STATE OF TENNESSEE
DEPARTMENT OF TRANSPORTATION
BUREAU OF ENGINEERING

I-65 INTERCHANGE AT BUCKNER ROAD
IN SPRING HILL (DESIGN-BUILD)

REV. 09/14/20: REVISED INDEX OF SHEETS.

TYPE	YEAR	PROJECT NO.	SHEET NO.
FUNCT.	2020		2

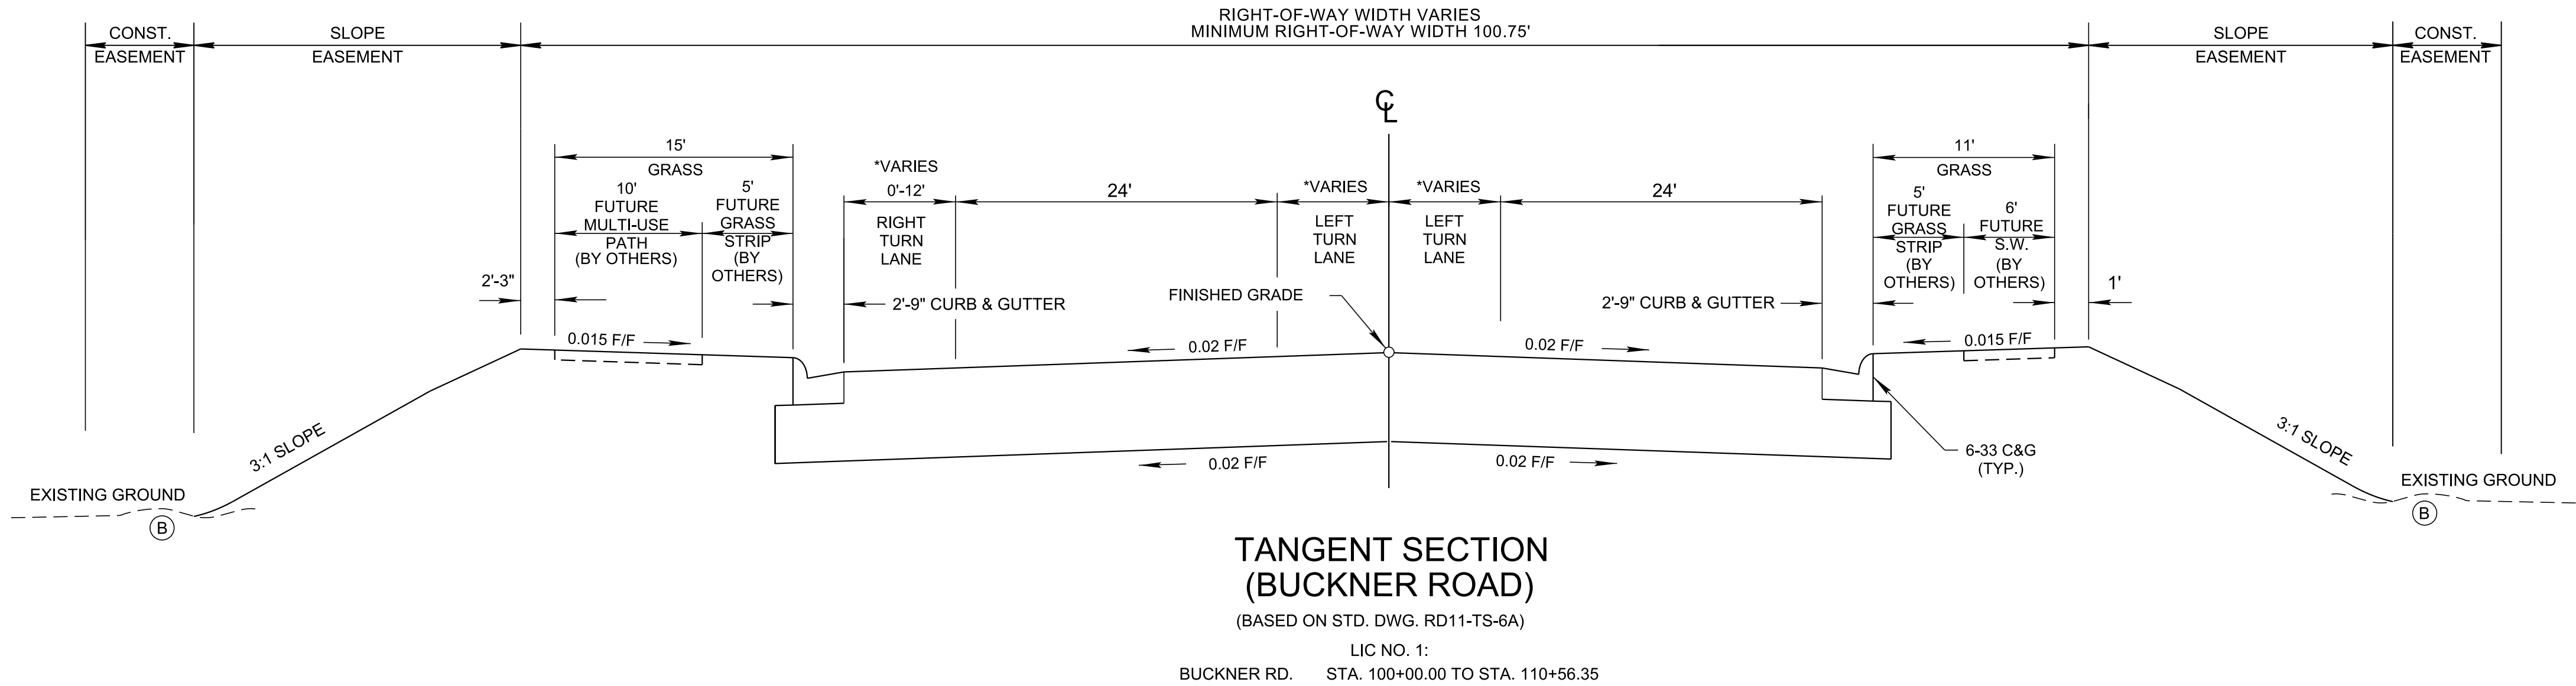
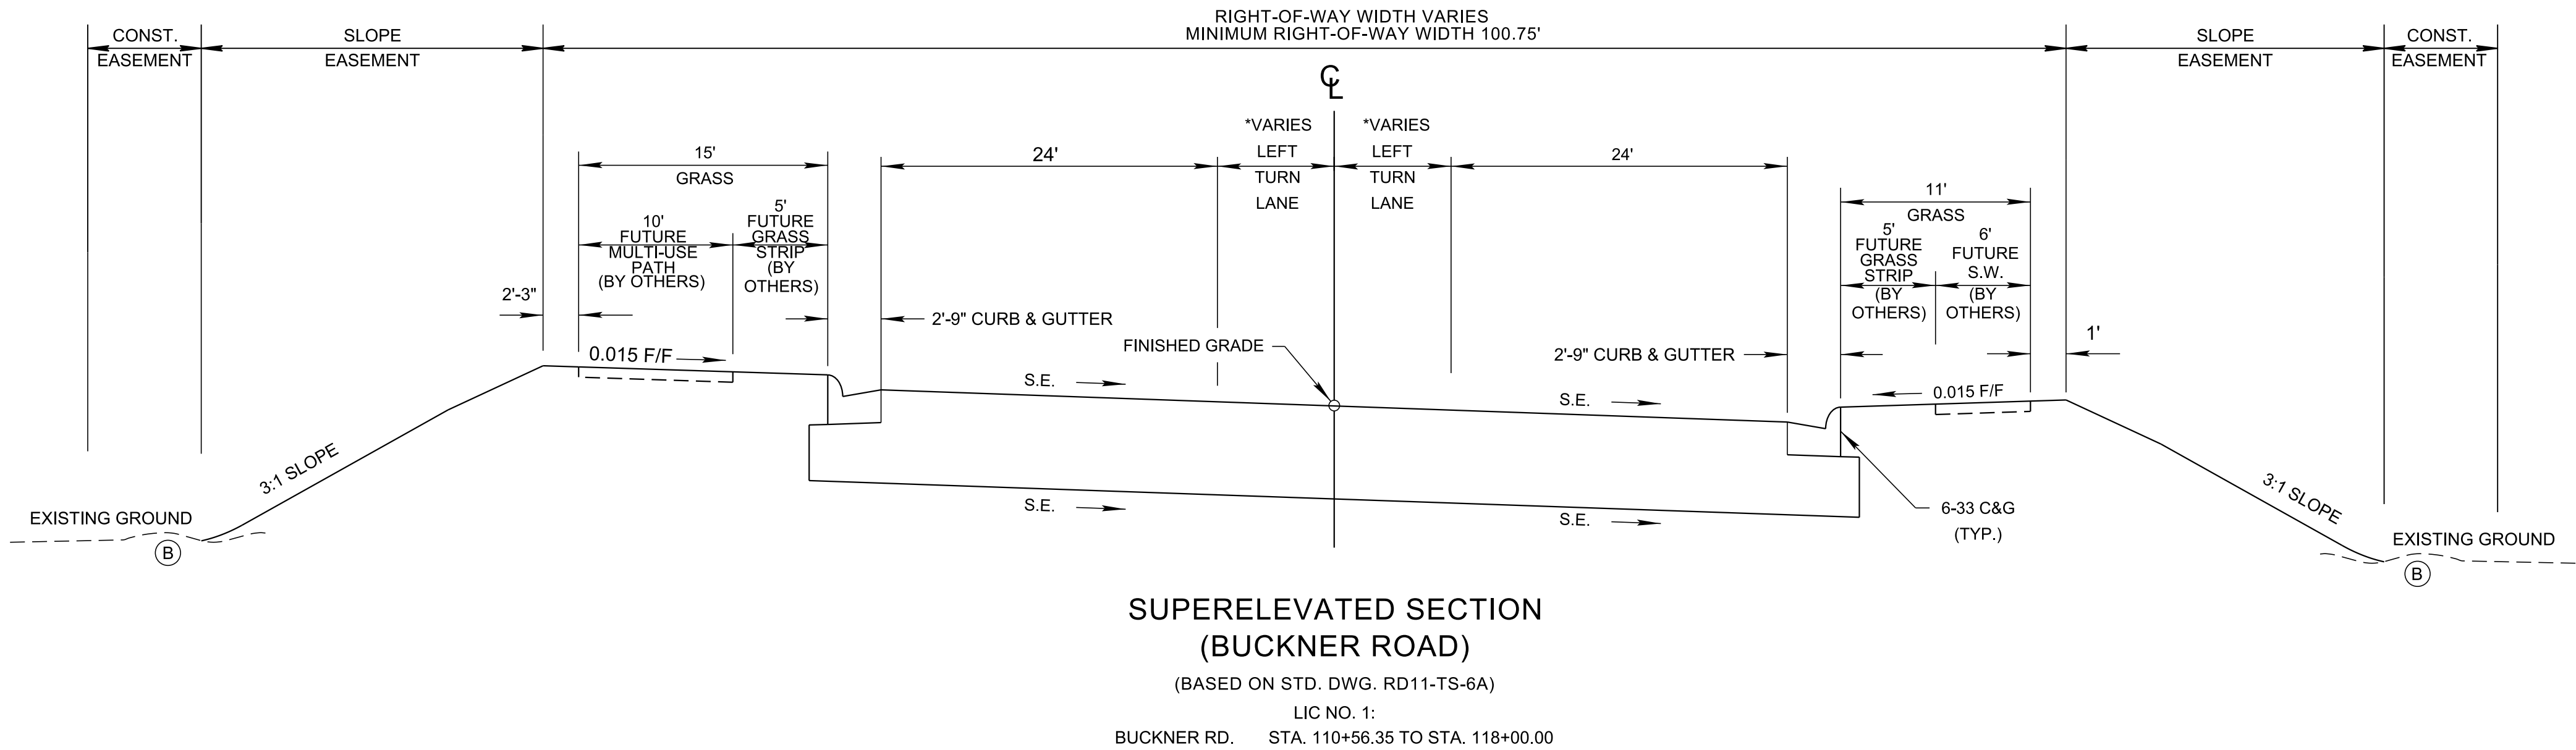
REV. 09/14/20: REVISED MINIMUM RIGHT-OF-WAY WIDTH. REMOVED CUT SECTION FROM BUCKNER ROAD TYPICAL SECTION, AND REVISED CUT SECTION DITCH DETAIL. REMOVED NOTE 2.

TYPE	YEAR	PROJECT NO.	SHEET NO.
FUNCT.	2020		2A

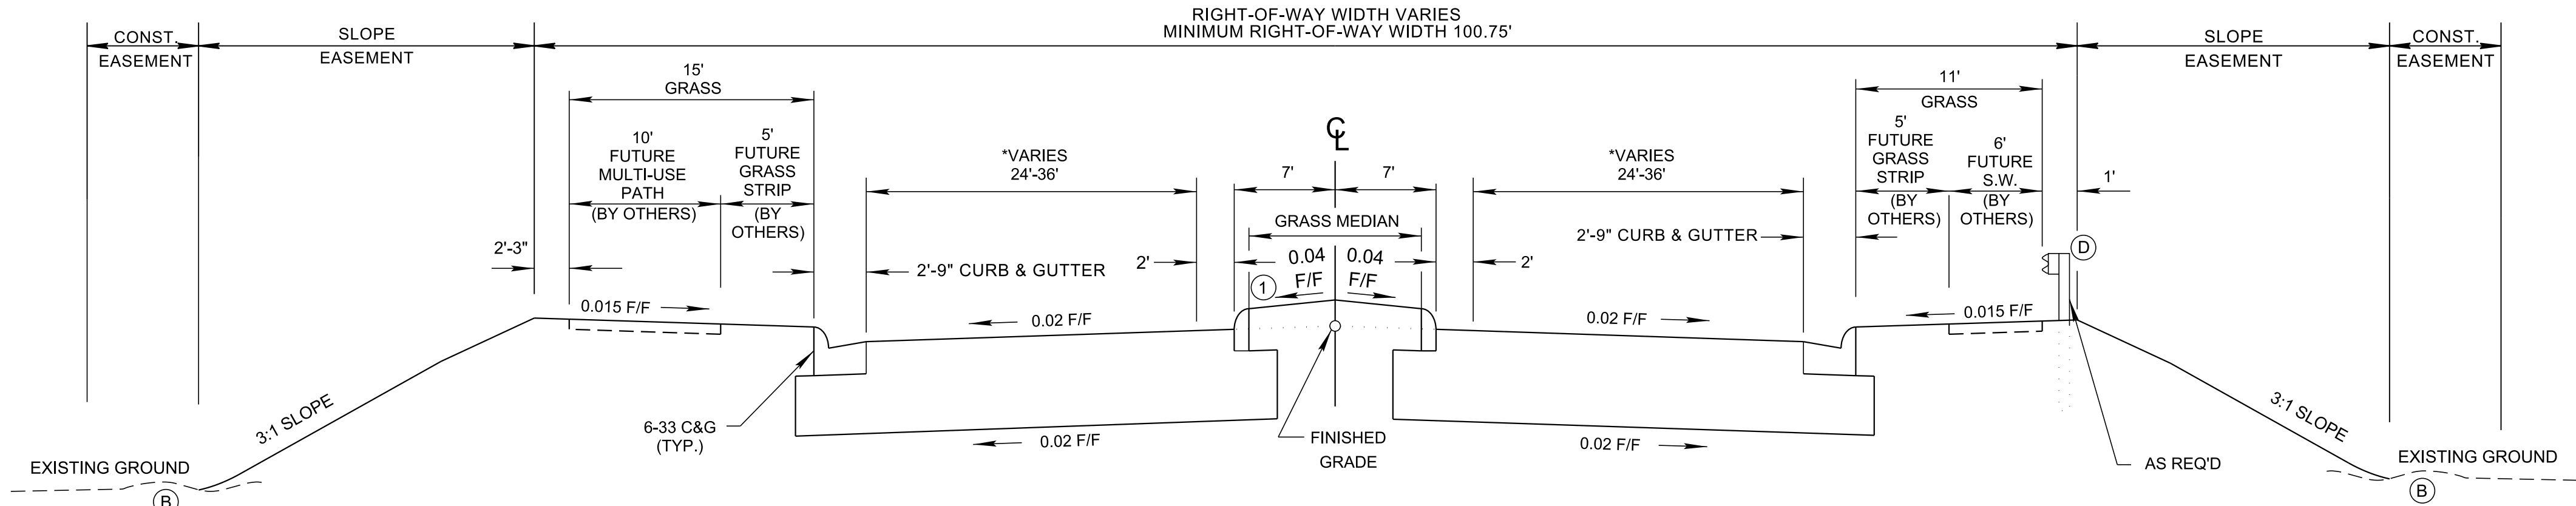
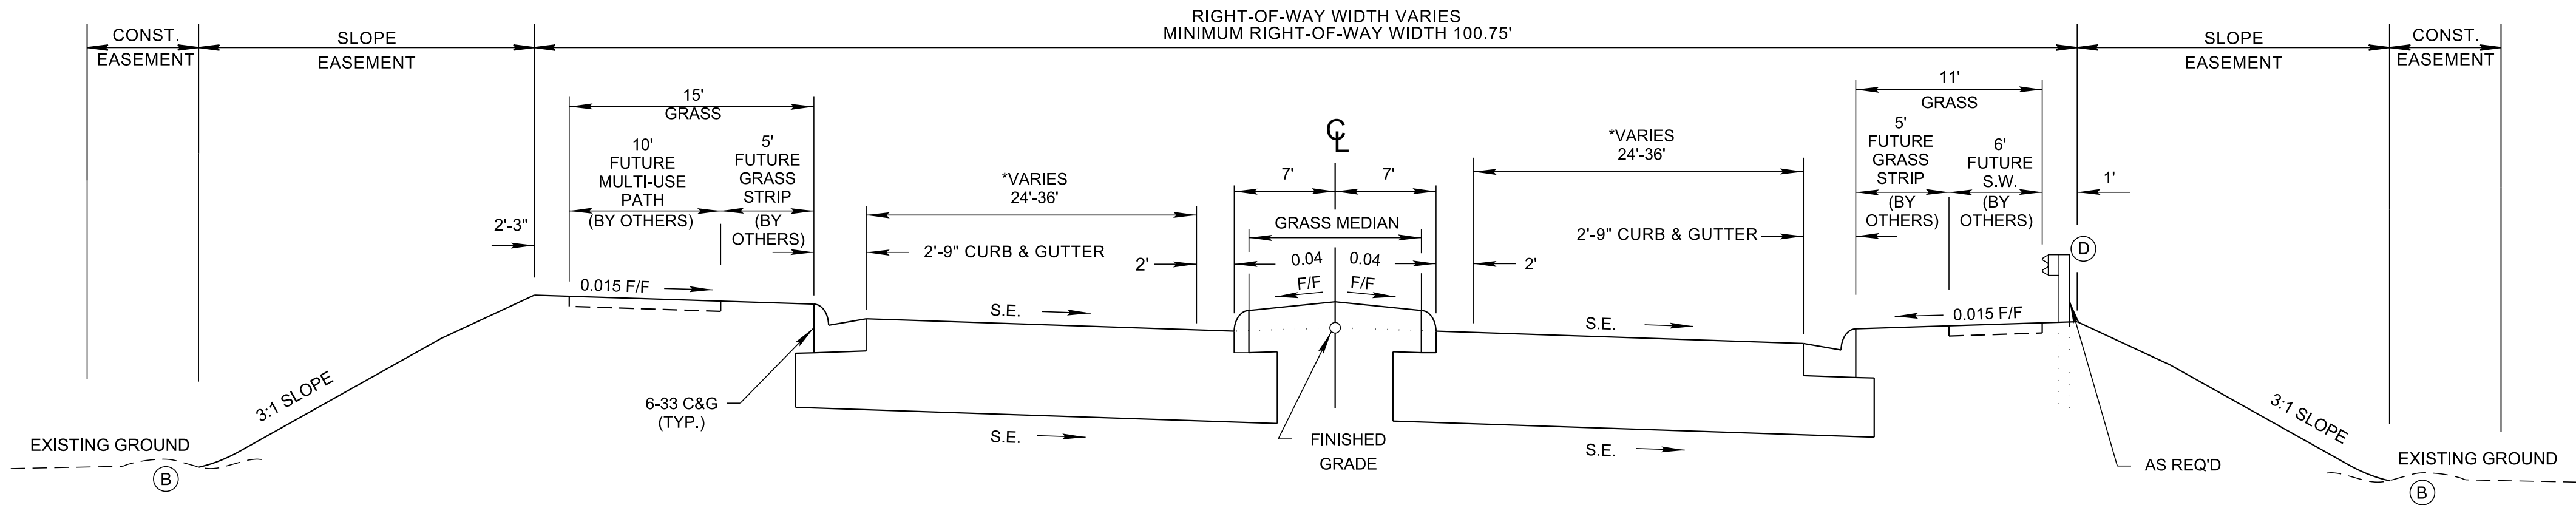
REV. 09/14/20: REVISED MINIMUM RIGHT-OF-WAY WIDTH. REVISED GUARDRAIL LOCATION ON BUCKNER ROAD TYPICAL SECTIONS. ADDED GUARDRAIL DETAIL. REMOVED CUT SECTION FROM BUCKNER ROAD TYPICAL SECTION AND ADDED CUT SECTION DETAIL TO SHEET. REMOVED NOTE 2.

TYPE	YEAR	PROJECT NO.	SHEET NO.
FUNCT.	2020		2B1

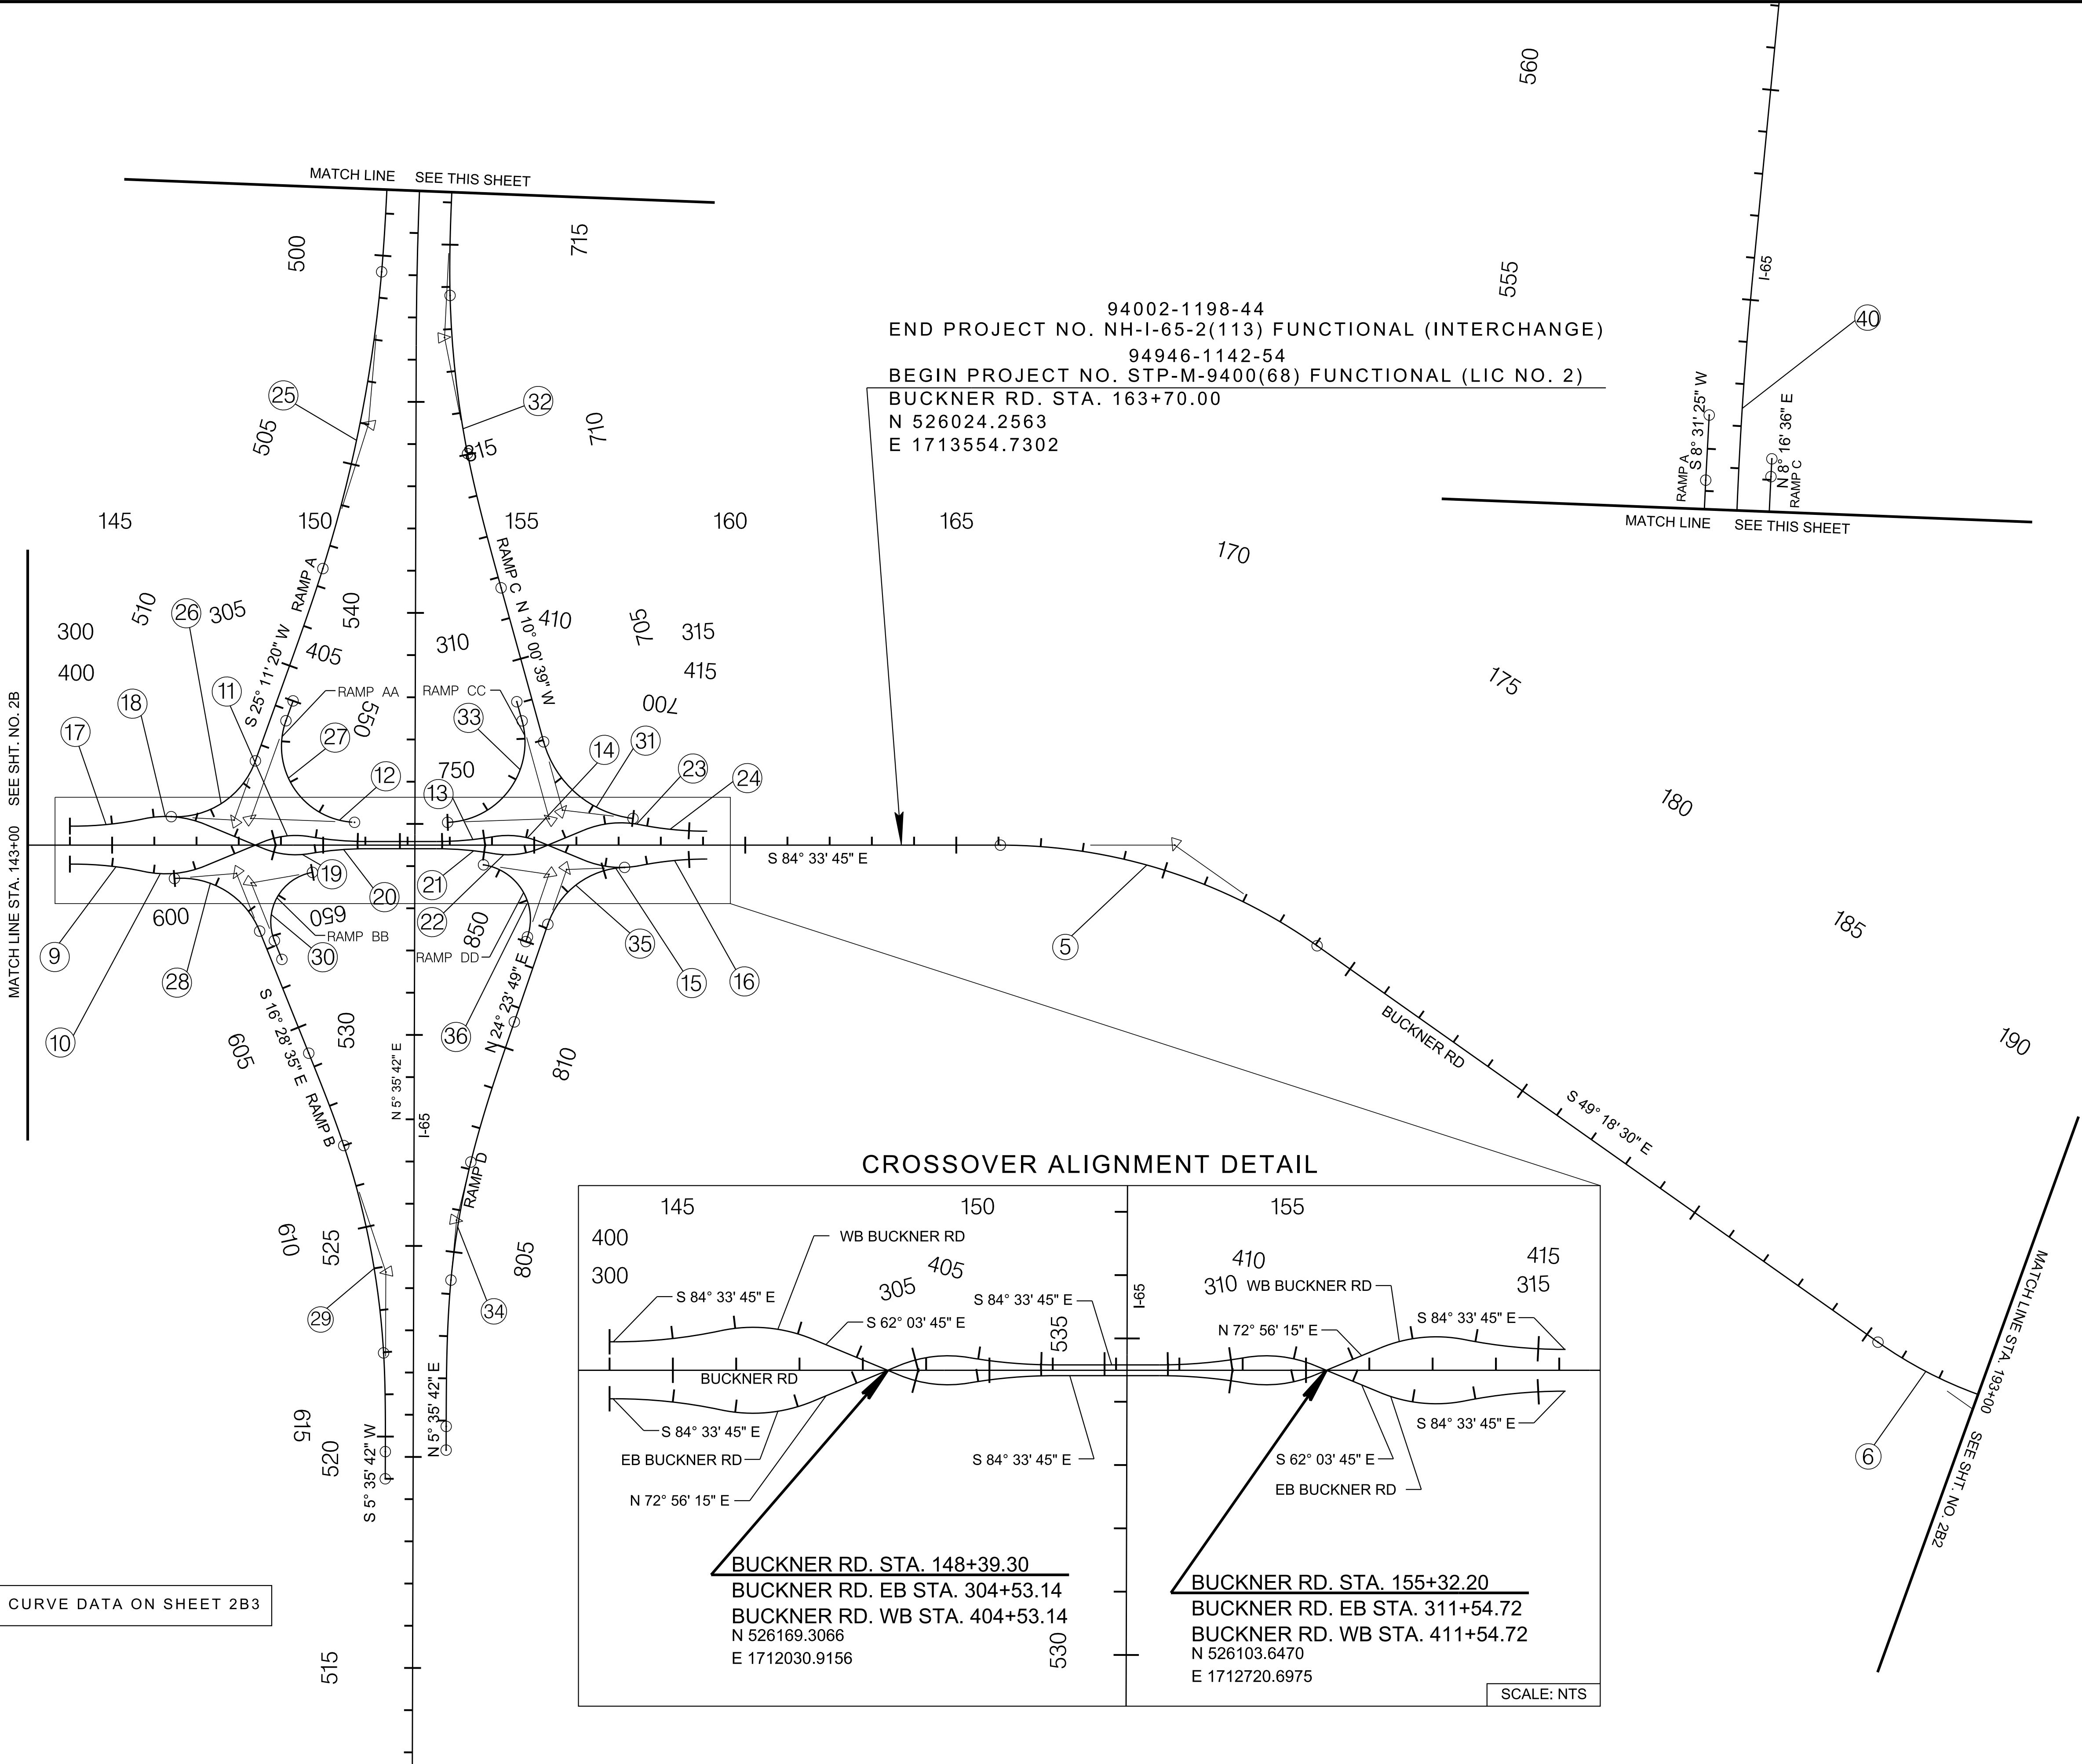
REV. 09/14/20: REVISED RAMP A AND RAMP D ALIGNMENTS.
